City of Canby

Public Works

Okada America
368 & 372 S Sequoia Parkway
October 26, 2021
Utility Notes

BACKBOARD DIAGRAM

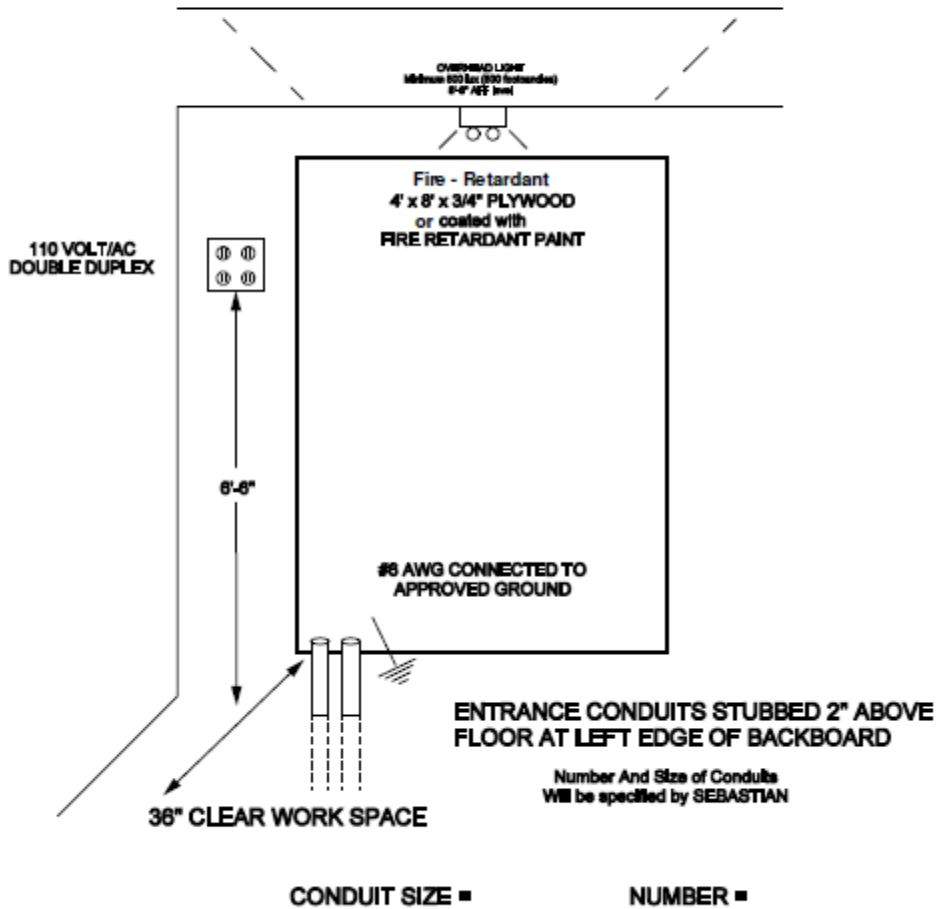
1. 2" schedule 40 PVC from the telephone connection point outside, into the Communication / power room with a 36" sweep (minimum).
 2. One 4'x8' 3/4" plywood backboard or coated with fire retardant paint.

3. #6 stranded grounds (MGN) connected to approved ground provided at the backboard.
 4. One 15 Amp electrical outlet located next to / or on backboard.
